# Yester Jeans Ltd (Extension Building)

Plot # 115-116, Adamjee EPZ, Siddhirganj, Narayanganj-1431.

19 June 2023

# Observations

Floor live load

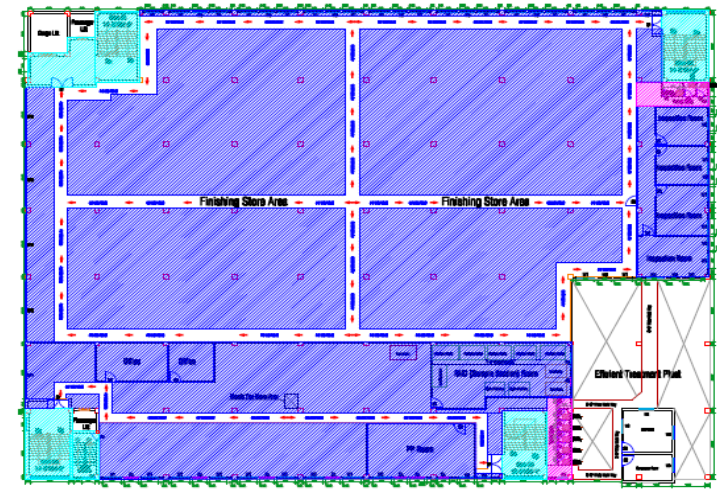
**Load plan & design report not comply  
with BNBC requirements**

The 1<sup>st</sup> floor of the building is being allotted for fabric store. As per BNBC, the minimum floor live load for light storage is 6 kN/m<sup>2</sup> (125 psf). But the storage area of the building is designed for 5 kN/m<sup>2</sup> live loads.

Building engineer is required to revise the storage live load limit and related design documents based on BNBC requirement.

## **Discrepancies in as-built drawings**

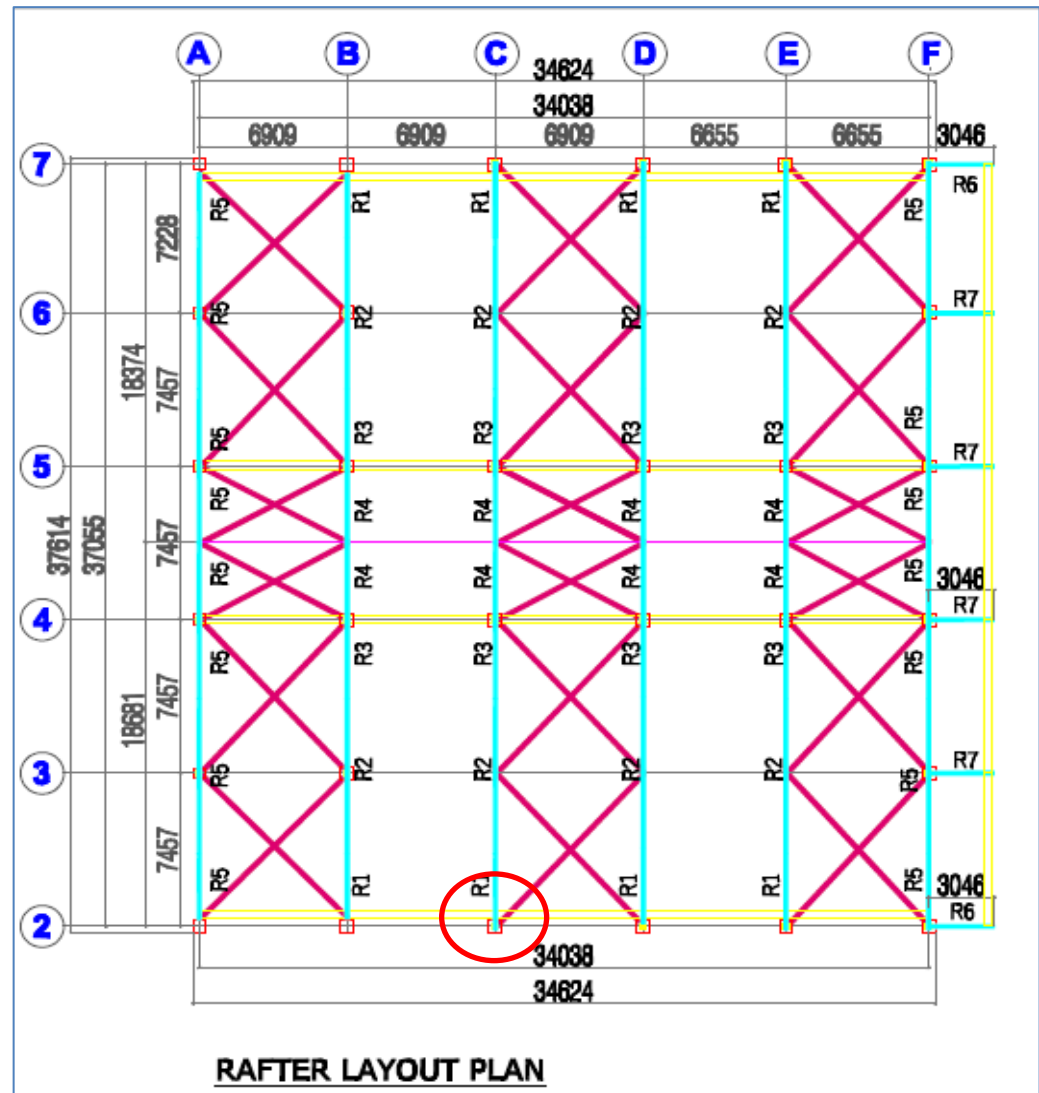
Lateral load transfer media (compression strut) was found offset along grid 2 at point C. Also, number of joint of rafter did not match with provided drawings. Building engineer is required to revise the drawings as per as-built condition and submit to RSC.

## **Incomplete design report**

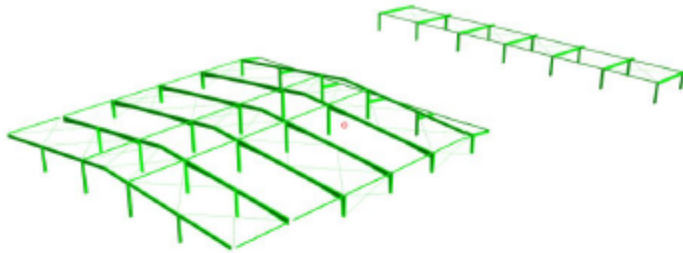
In the design report, wind load calculation for roof shed and rafter deflection check was not found. Building engineer is required revised the design report incorporating all the missing information.
